Model Administrative Change Notice

1. Document Number:	MDL-MGR-GS-000007	2. Revision:	00	3. ACN:	01
4. Title:	Supplemental Earthquake Ground Motion Input for a Geologic Repository at Yucca Mountain, NV				
5. No. of Pages Attached	8

Figure 6.1-1 Flow Diagram for Developing Earthquake Ground Motion Inputs

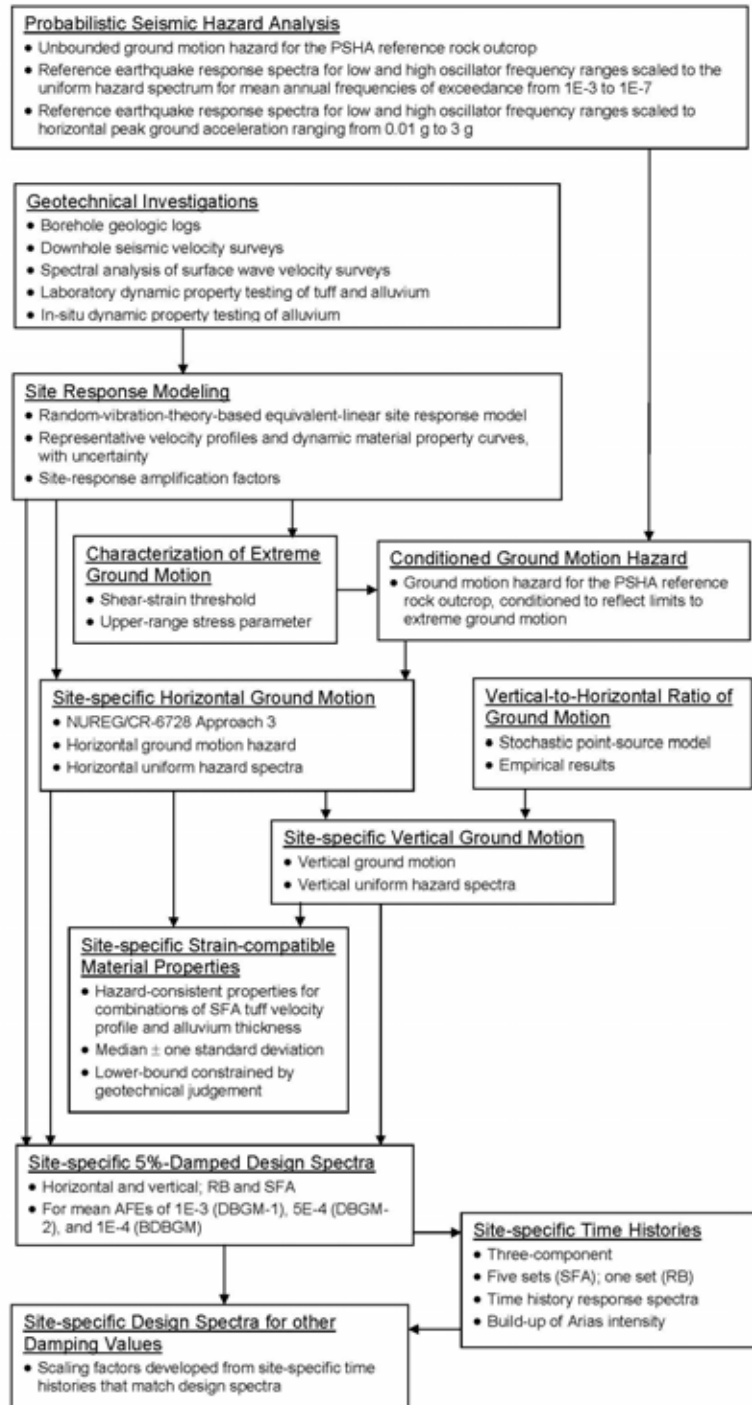
7. Affected Pages	8. Description of Change:				
6-3	In Figure 6.1-1, added a connector from the "Site-specific Horizontal Ground Motion" box to the "Site-specific 5%-damped Design Spectra" box and adjusted the positions of other connectors as necessary.				
6-142	In Figure 6.4.2-3, revised the X-axis label from "Shear Wave Velocity..." to "Seismic Velocity..." revised caption to "2004 Base Case V_s and V_p Profiles Developed for the RB," and deleted note.				
6-233	In Figure 6.4.2-94, removed the unsmoothed profile for the 2004 Tuff Base Case and reshaped legend box.				
6-261; 6-262	In each of Figures 6.5.1-7 and 6.5.1-8, corrected the right-axis scale to be consistent with the left-axis scale.				
6-312	Replaced the data plot in Figure 6.5.2-34 with the data plot from original Figure 6.5.2-41, and then corrected the right-axis scale to be consistent with the left-axis scale, corrected the top-axis scale to be consistent with the bottom-axis scale, and extended the "Mean-Horizontal" curve to the upper left.

Figure 6.5.2-41. Mean Horizontal and Vertical Seismic Hazard Curves for 3.3 Sec SA at SFA

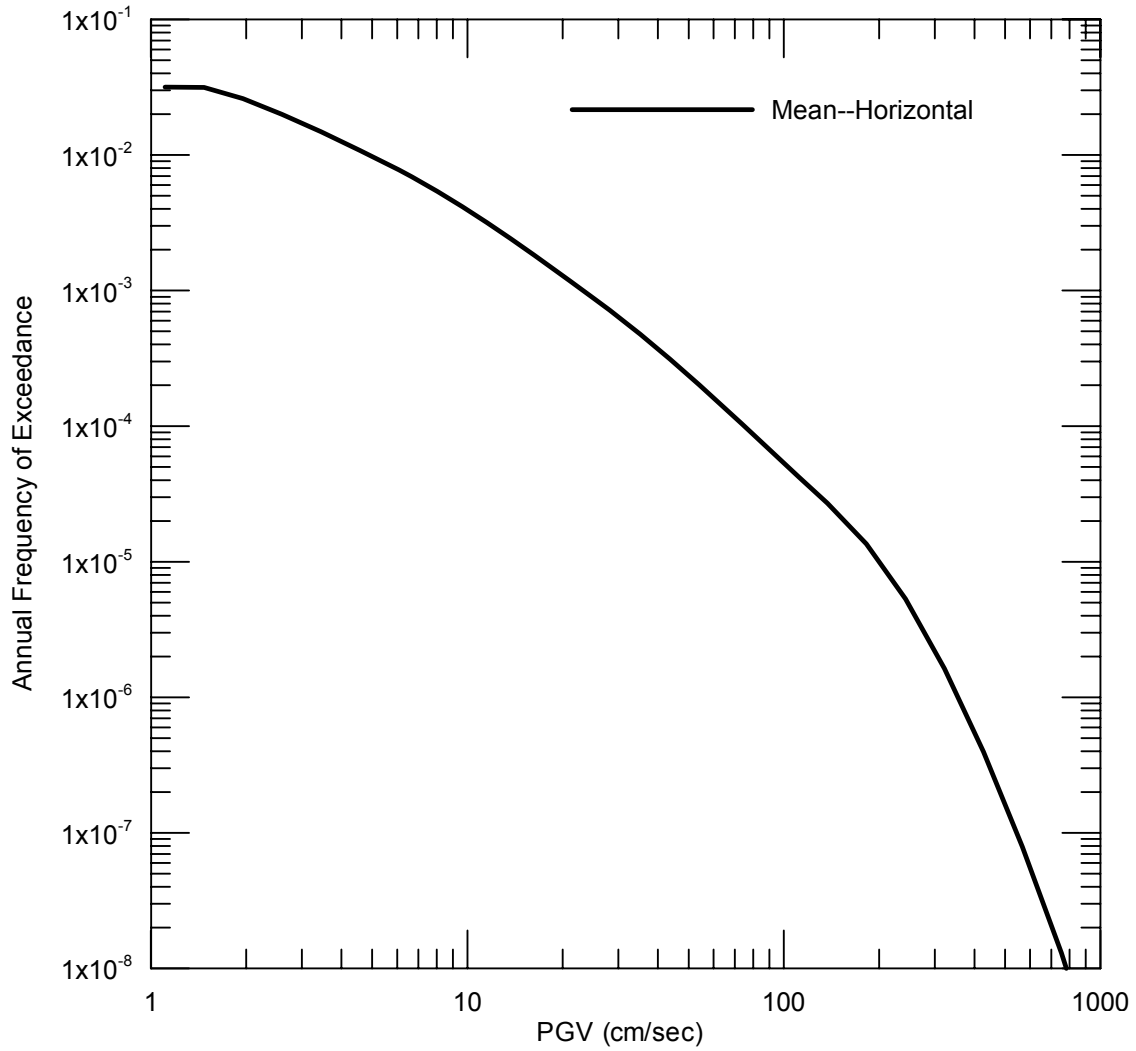
6-319	Replaced the data plot Figure 6.5.2-41 with the data plot from original Figure 6.5.2-34, and then corrected the right-axis scale to be consistent with the left-axis scale.				
6-320	In Figure 6.5.2-42, corrected the right-axis scale to be consistent with the left-axis scale, and corrected the top-axis scale to be consistent with the bottom-axis scale.
